City of Portland, Maine - Building or Use Permit Application

Location of Construction: 74 Chesley Ave	Owner Name: Marley	Owner Address: 74 Chesley Ave	Phone: 207-878-9930
Business Name: n/a	Contractor Name: Towns, Charles	Contractor Address: 278 Maine Ave Portland	Phone: 2077972174
Lessee/Buyer's Name n/a	Phone: n/a	Permit Type: Additions - Dwellings	Zone: R-3

Past Use: Single Family	Proposed Use: Single Family / 14' x 12' family room addition & 7' x 12' deck. ** Call Charles G Towns 797-2174.	Permit Fee: \$114.00	Cost of Work: \$14,400.00	CEO District: 2	7,582
----------------------------	--	-------------------------	------------------------------	--------------------	-------

New Addition 14' x 12'

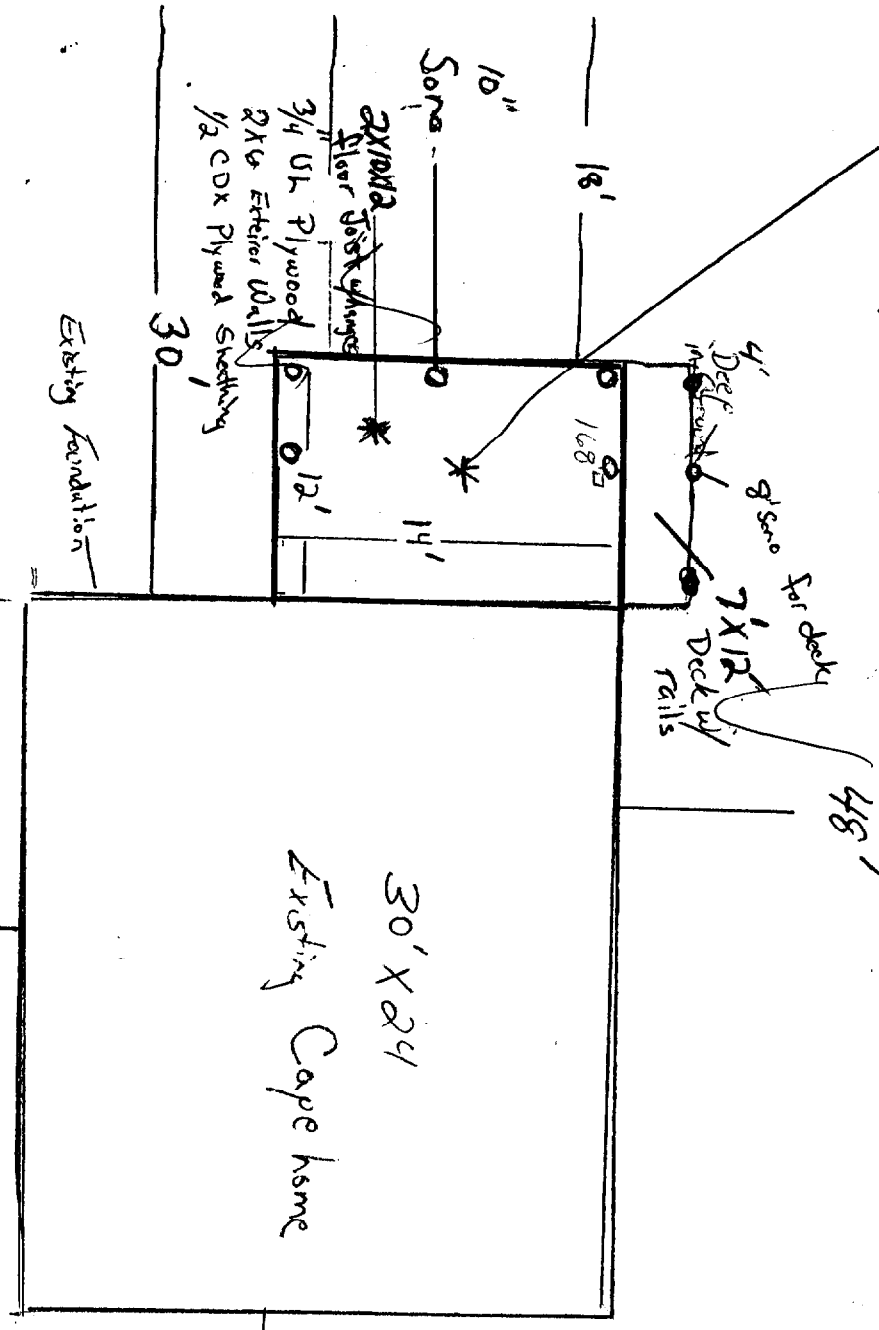
5-25-01: Met Contractor & Owner @ file reviewed plans
& checked lot books, Found property to have
large deck & above ground pool behind house
near of pool @ < 10' from Rear line ~~25' required.~~
Instructed owner to re submit plan showing pool
& Deck as built. (116)

PAR 25' req - 41' shown
 Side 8' req - 18' shown
 front 25' req 35' + shown
 20

Pool OK — Installed 8-10 yrs ago!
Setback to Rear line 10+ feet.
JB
